SECTION AA
SCALE: 1/4" = 1'-0"

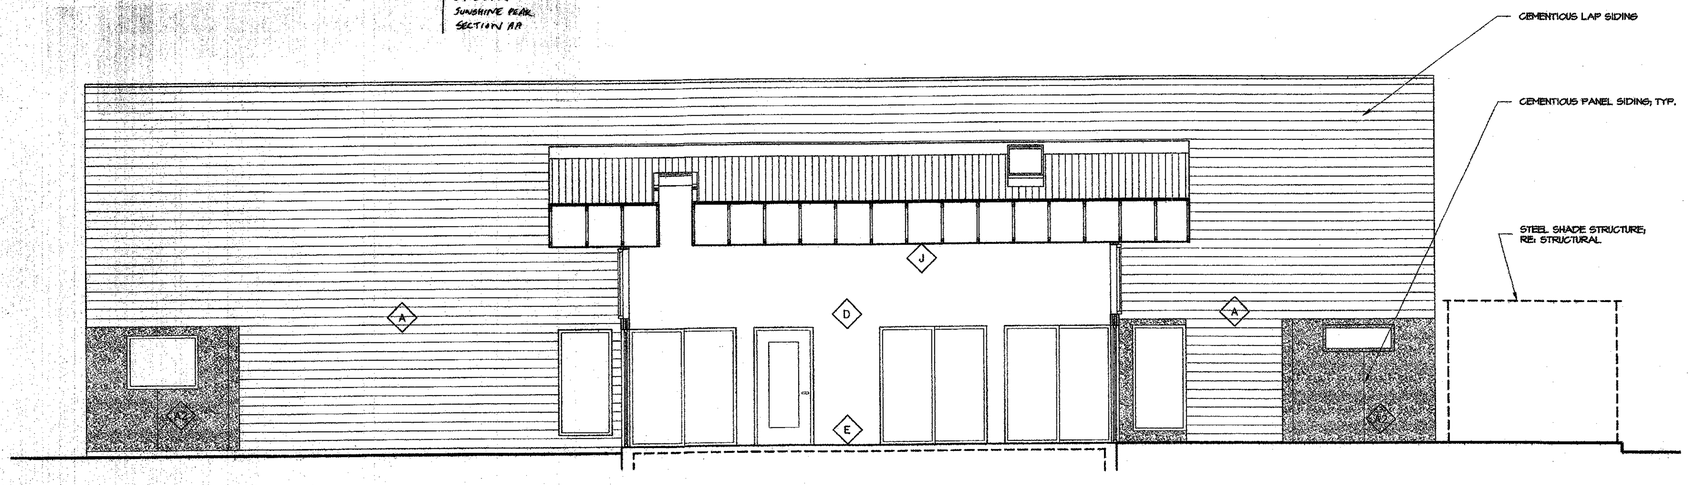
Sheet CB04 of 37 – Section AA: See attached Sheet 10 for additional window header elevations.

1 SECTION CC
SCALE: 1/4" = 1'-0"

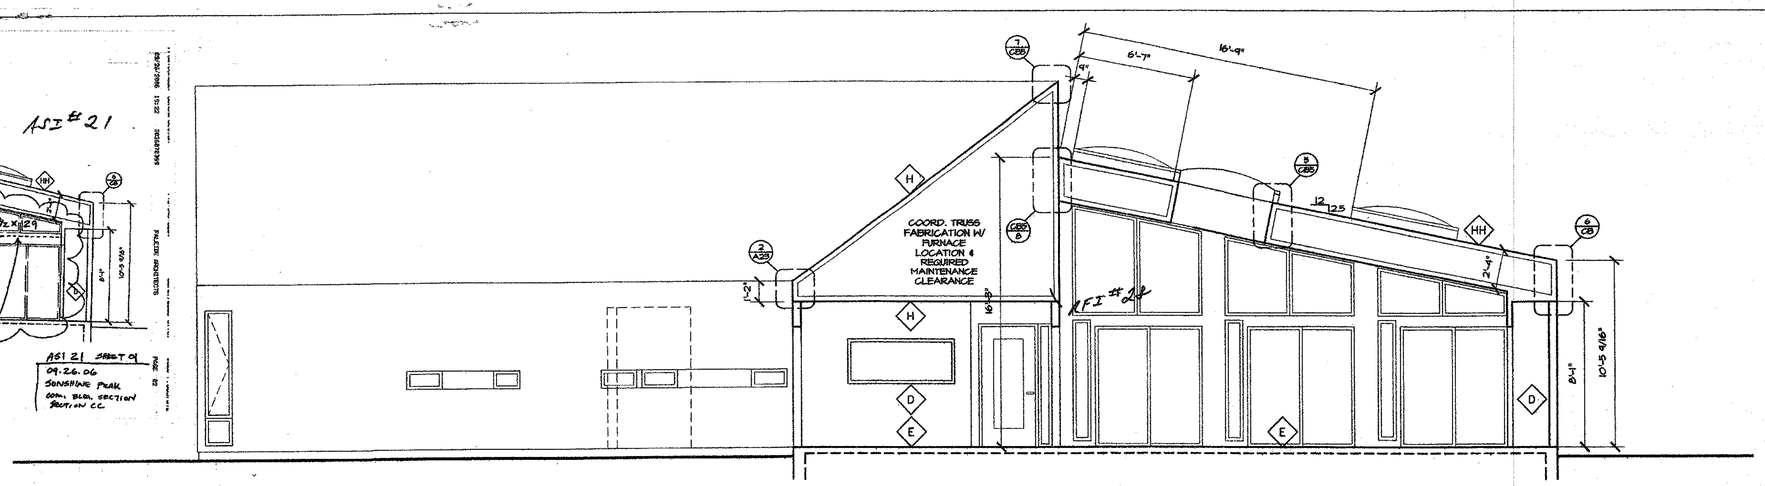
Sheet CB05 of 37 – Section CC: See attached Sheet 01 for window header elevations and reference to structural detail.

5 PLEX ROOF FRAMING PLAN

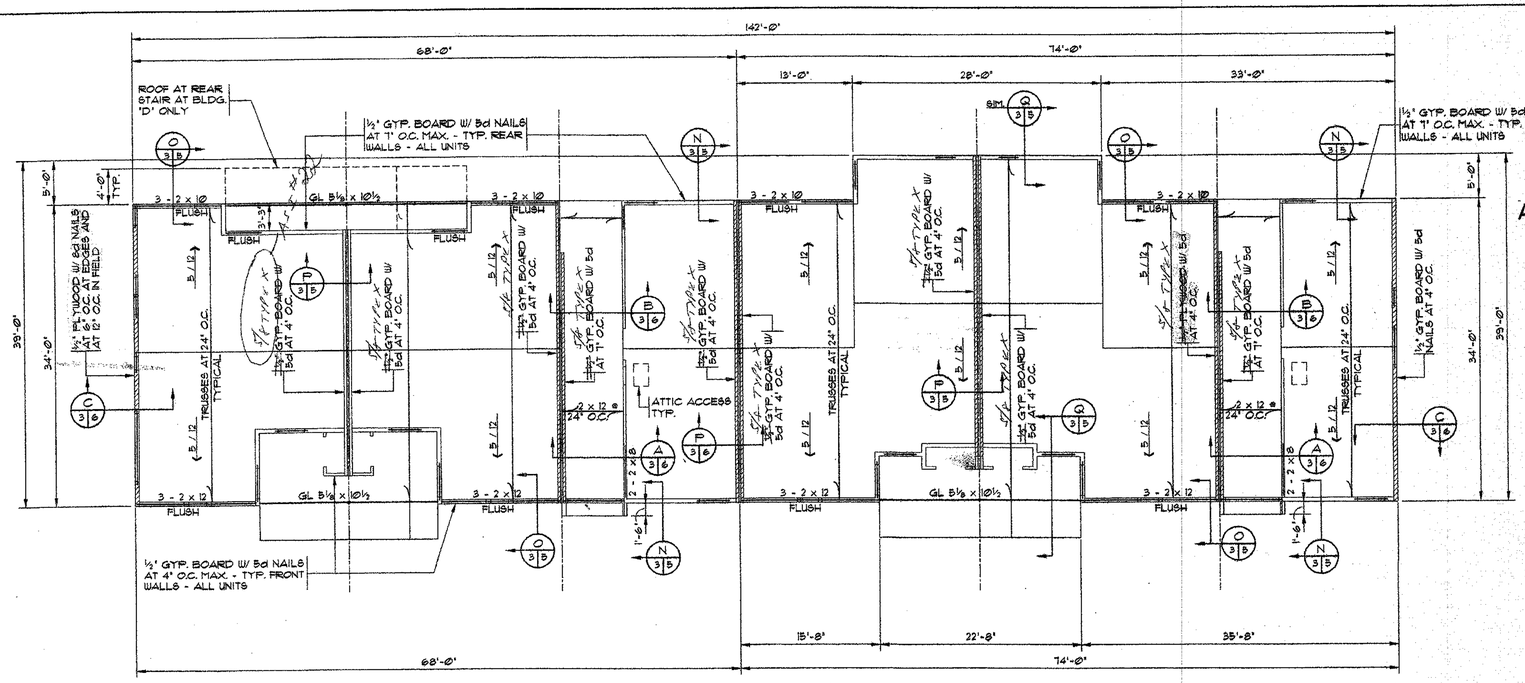
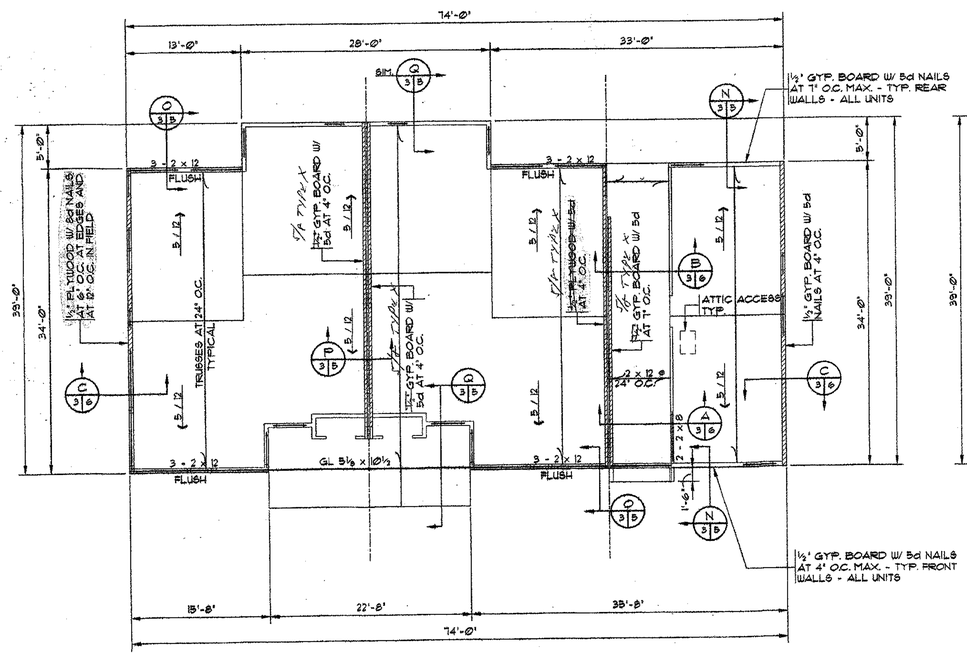
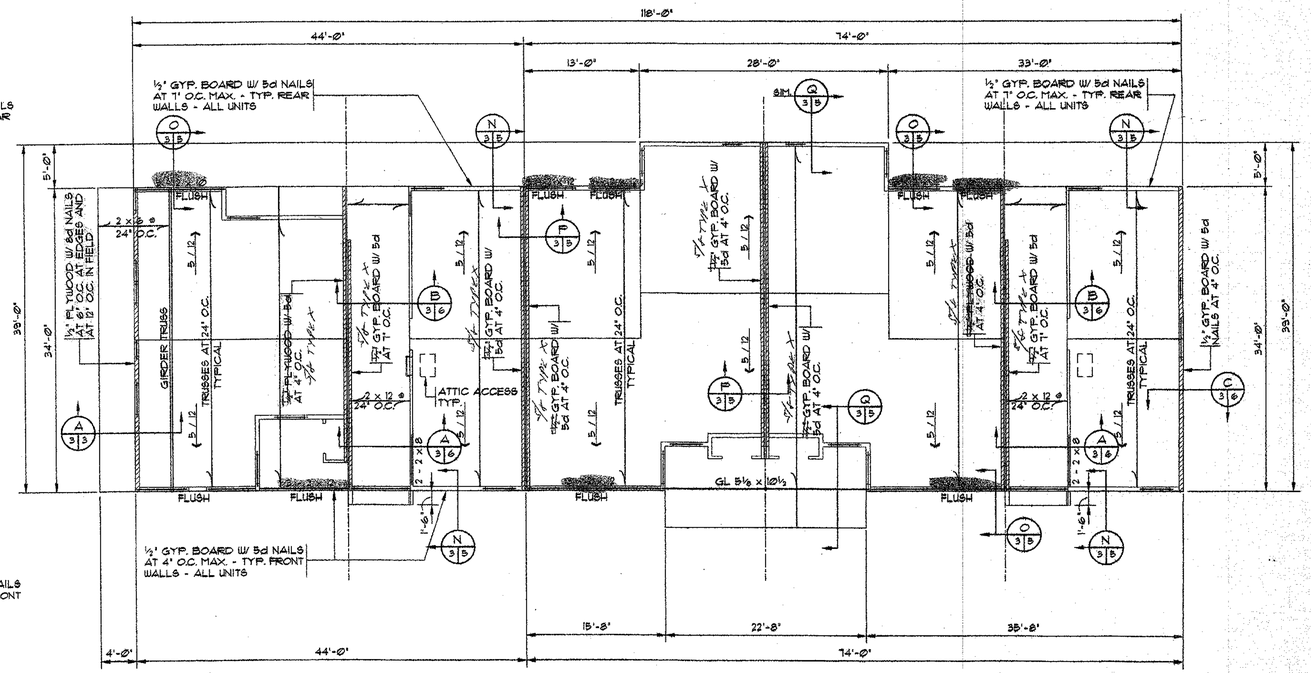
Sheet 33 of 7 – 5-plex Roof Framing Plan: 5/8" Type "X" Gypsum Wall board is to be used at party wall locations in lieu of the reference to ½" plywood or ½" Gyp. bd. See systems note "C" on Sheet A01 of 07. Nailing pattern shown on Sheet 33 of 7 still applies.

Sheet 33 of 7 – 6-plex Roof Framing Plan: 5/8" Type "X" Gypsum Wall board is to be used at party wall locations in lieu of the reference to ½" plywood or ½" Gyp. bd. See systems note "C" on Sheet A01 of 07. Nailing pattern shown on Sheet 33 of 7 still applies.

Sheet 33 of 7 – 10-plex Roof Framing Plan: 5/8" Type "X" Gypsum Wall board is to be used at party wall locations in lieu of the reference to ½" plywood or ½" Gyp. bd. See systems note "C" on Sheet A01 of 07. Nailing pattern shown on Sheet 33 of 7 still applies.

MODULE 1 MAIN FLOOR PLUMBING PLAN

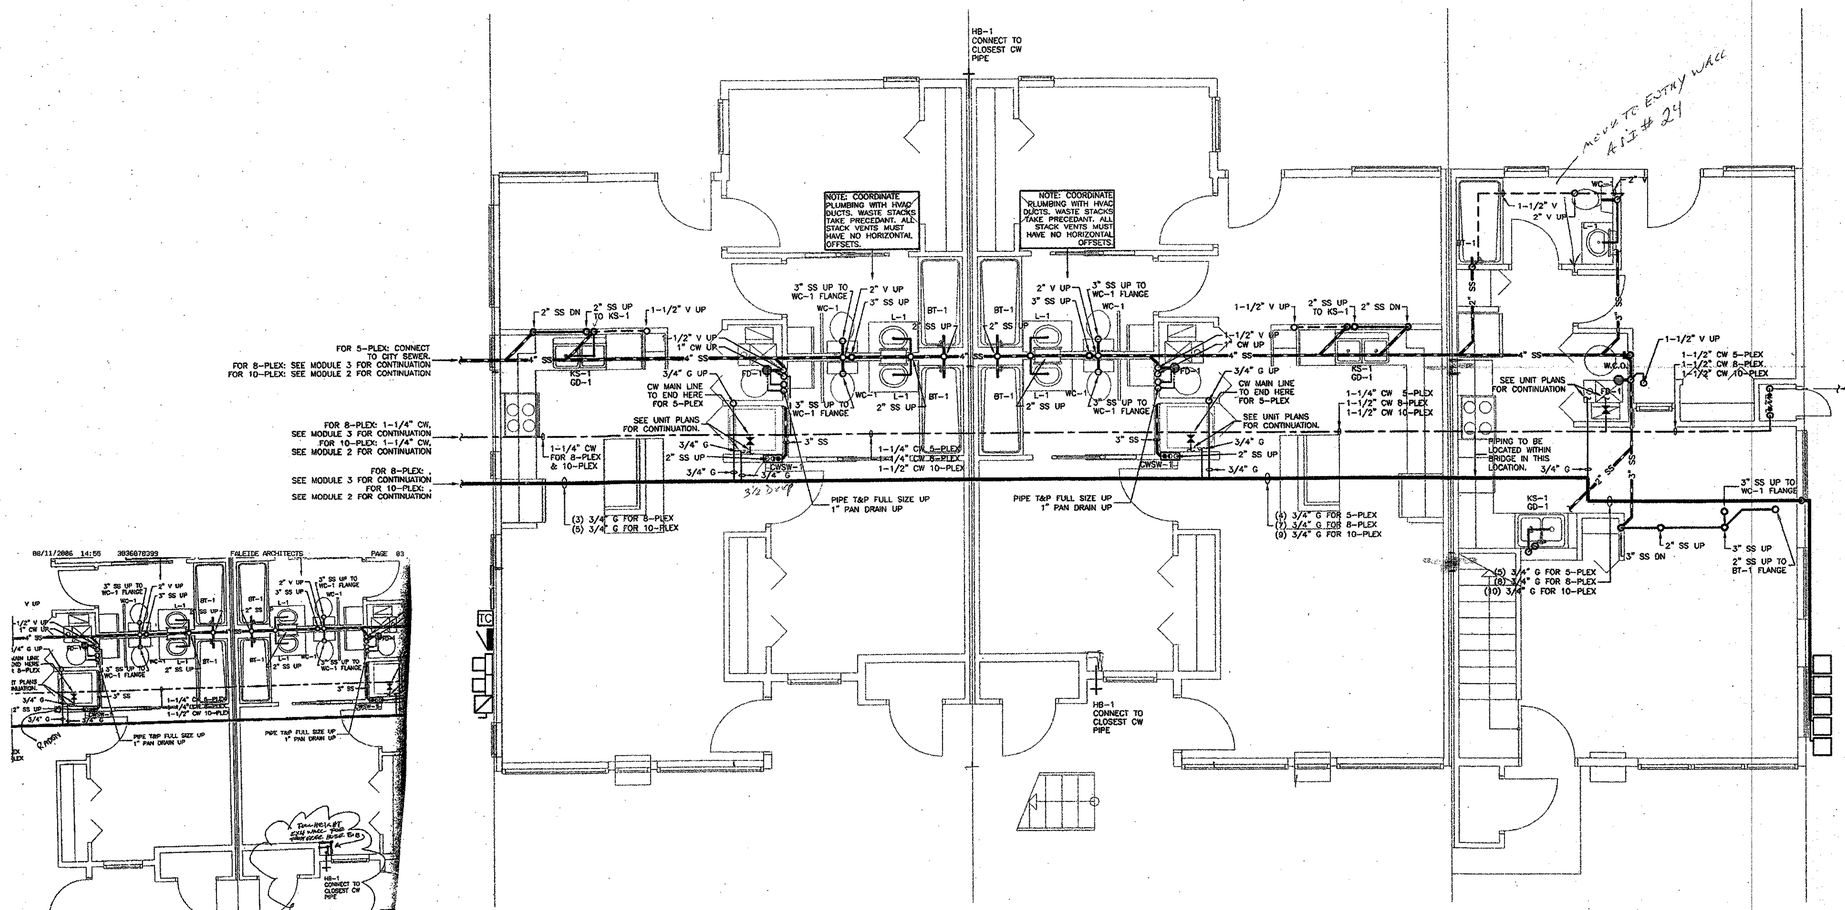
Sheet P1 – Module 1 Main Floor Plumbing Plan: At the 8-plex building, in lieu of (8) ¾" gas lines, there shall be (8) ¾" gas lines that feed Module 1 and (3) 1" gas lines that feed Module 3.

Sheet P1 – Module 1 Main Floor Plumbing Plan: At the 10-plex buildings, in lieu of (10) ¾" lines, there shall be (8) ¾" gas lines that feed Module 1 and (5) 1" gas lines that feed Module 2.

MODULE 2 UPPER FLOOR PLUMBING PLAN

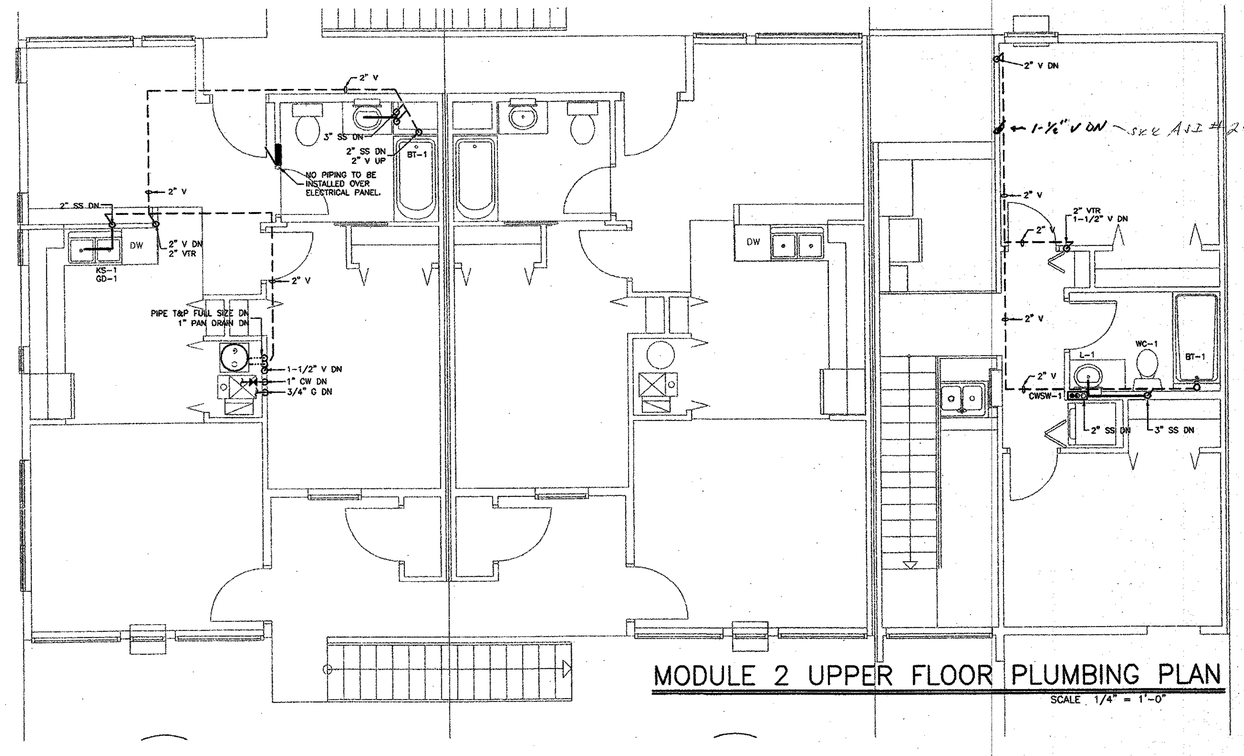
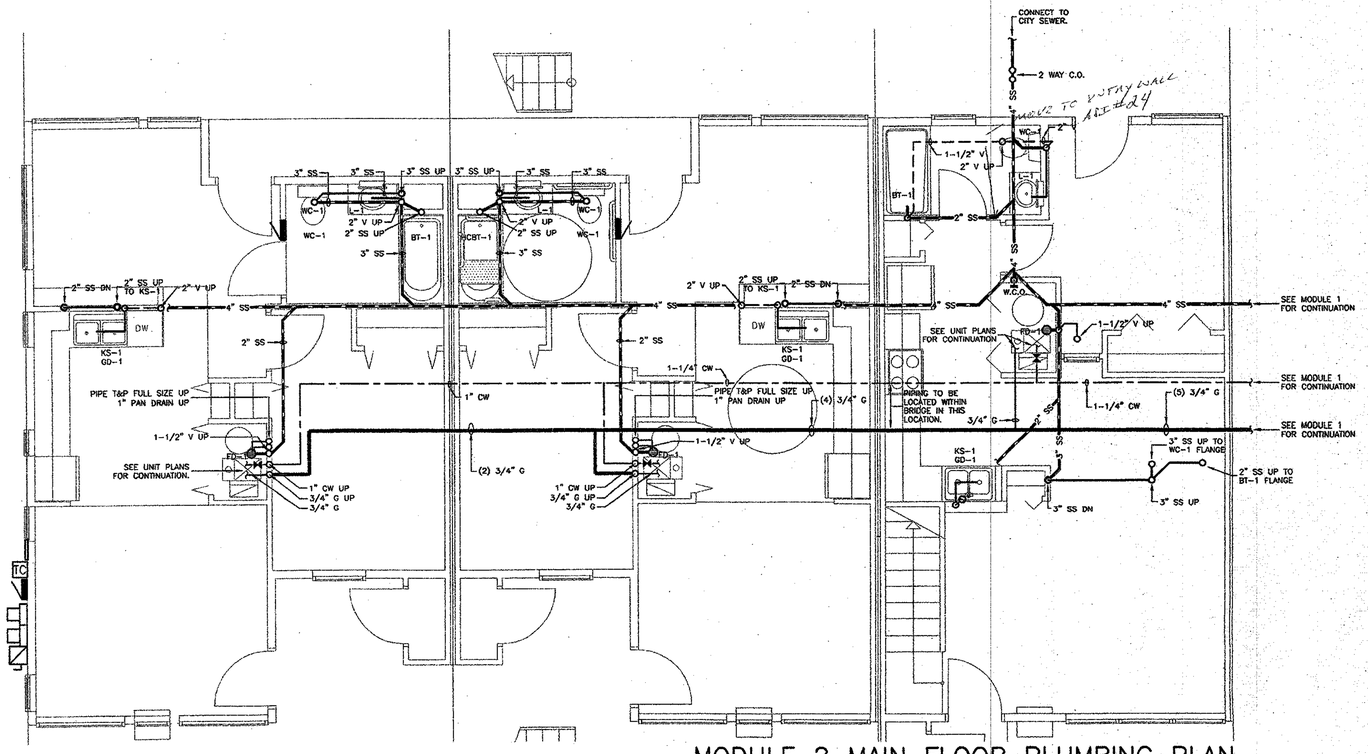
Sheet P3 – Module 2 Main Floor Plumbing Plan and Module 2 Upper Floor Plumbing Plan: In lieu of ¾" gas lines feeding Module 2, there shall be 1" gas lines feeding Module 2.

MODULE 3 UPPER FLOOR PLUMBING PLAN

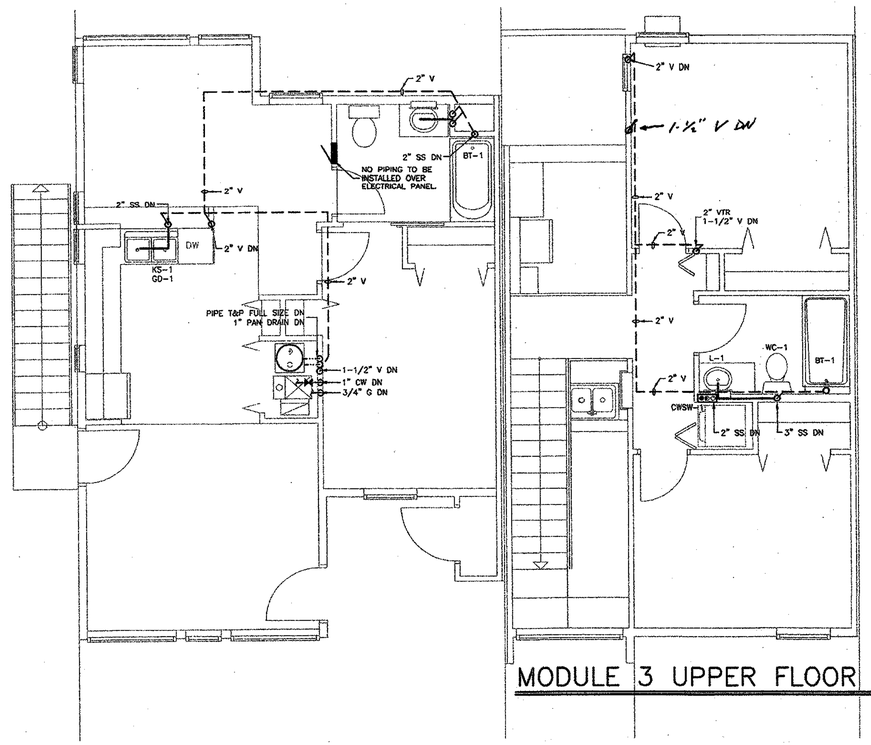
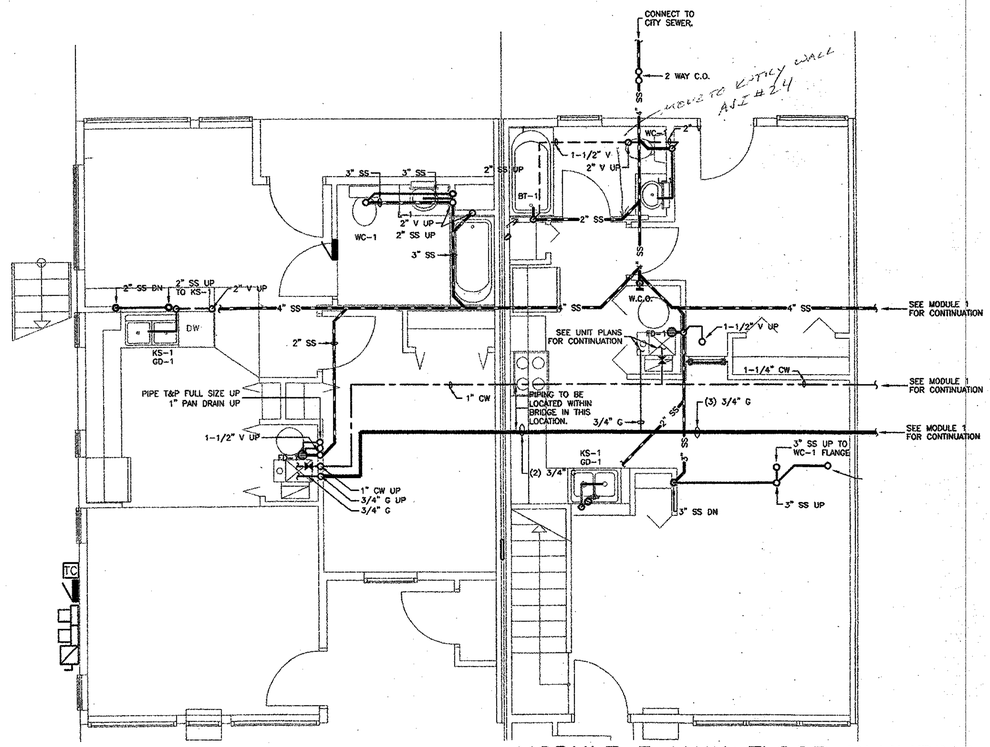
Sheet P4 – Module 3 Main Floor Plumbing Plan and Module 3 Upper Floor Plumbing Plan: In lieu of ¾" gas lines feeding Module 3, there shall be 1" gas lines feeding Module 3.
